UNITED STATES PATENT AND TRADEMARK OFFICE

Office Action Summary

10/557,516

DETAILED ACTION

Figure 2

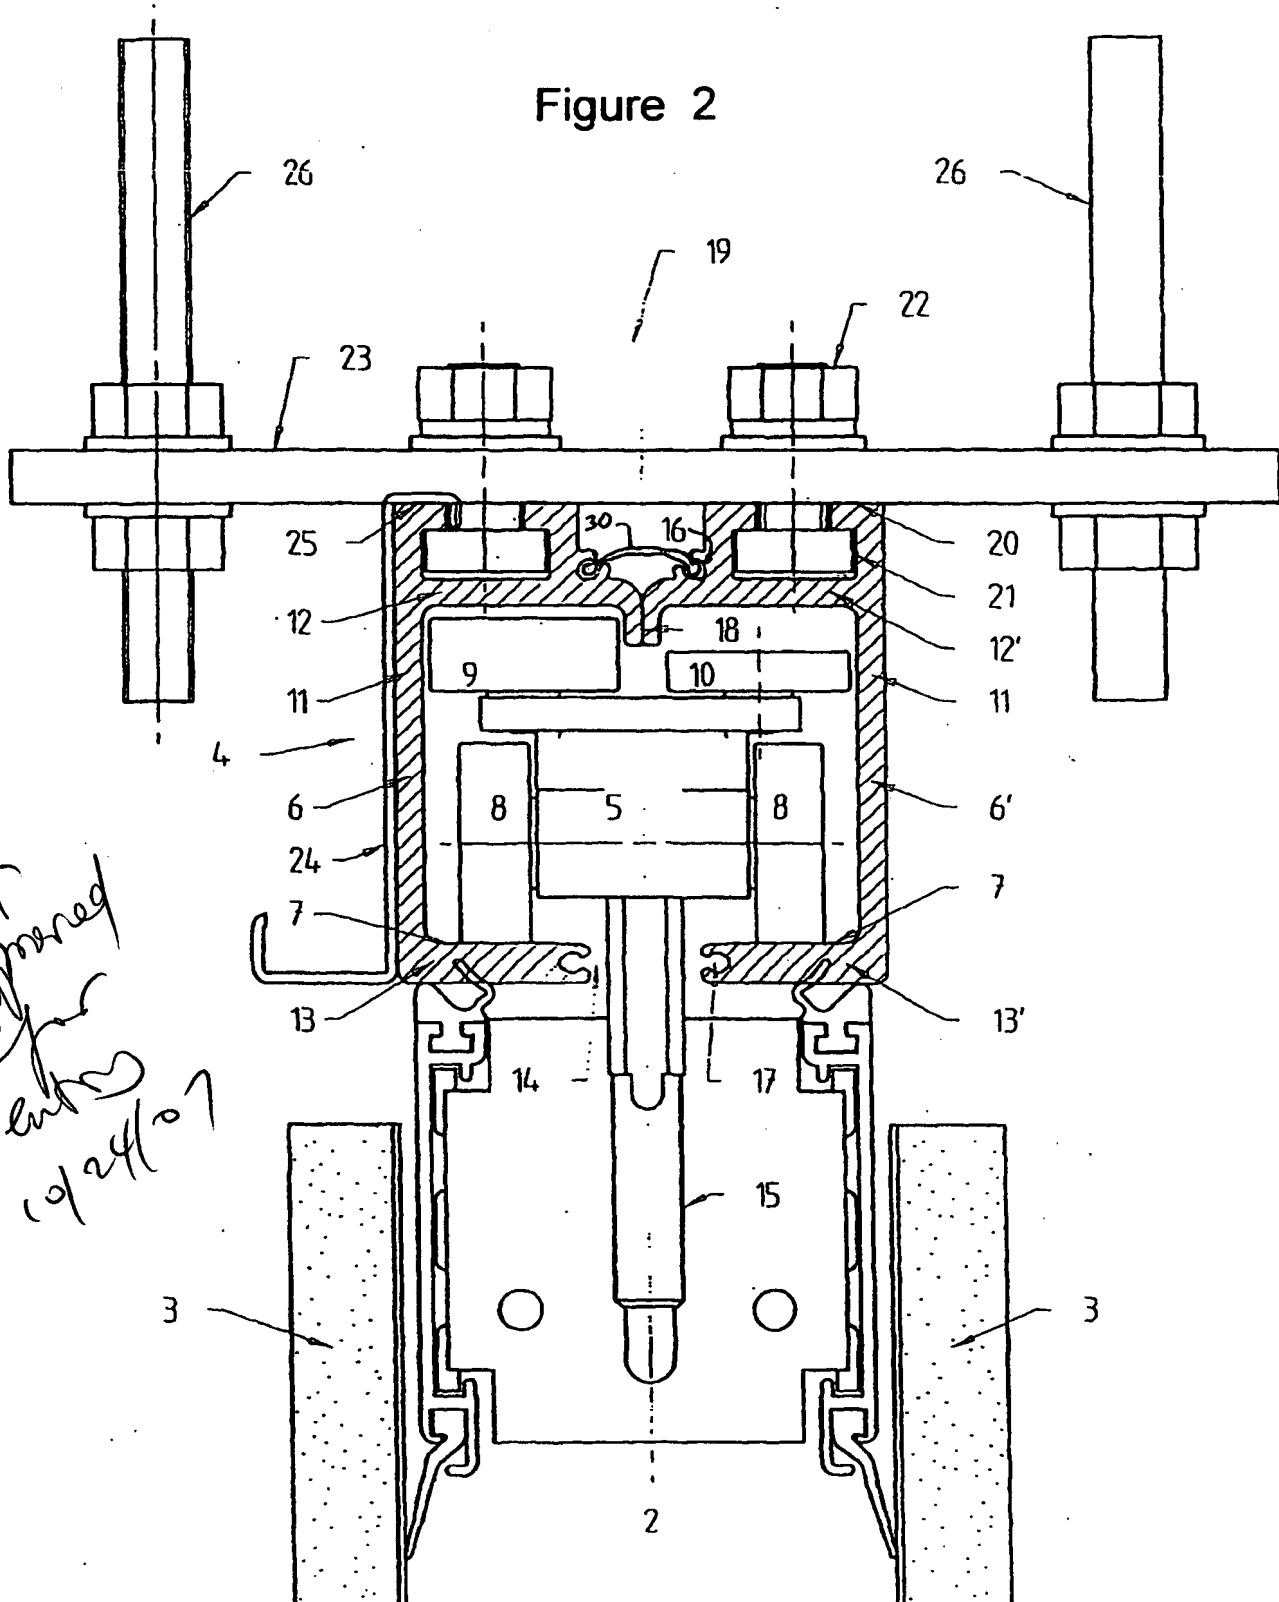
1. The replacement sheet containing Figure 2, filed on November 21, 2005, is not approved for entry because the configuration of structure 30 and how it is associated with the apertures in the first and second rails, as shown in the proposed Figure 2, is not fully supported by the originally filed disclosure.

3. The drawings are objected to under 37 CFR 1.83(a). The drawings must show every feature of the invention specified in the claims. Therefore, the centering element received in the pair of apertures so that each centering element is received in one of the apertures of the first rail and in one of the apertures in the second rail, as recited in the last paragraph of claim 6, must be shown or the feature must canceled from the claim(s). No new matter should be entered.

not approved for
10/24/07

2. Since the proposed drawing correction has not been approved for entry, any corresponding changes in the specification should be removed so as to maintain consistencies between the specification and the drawings.
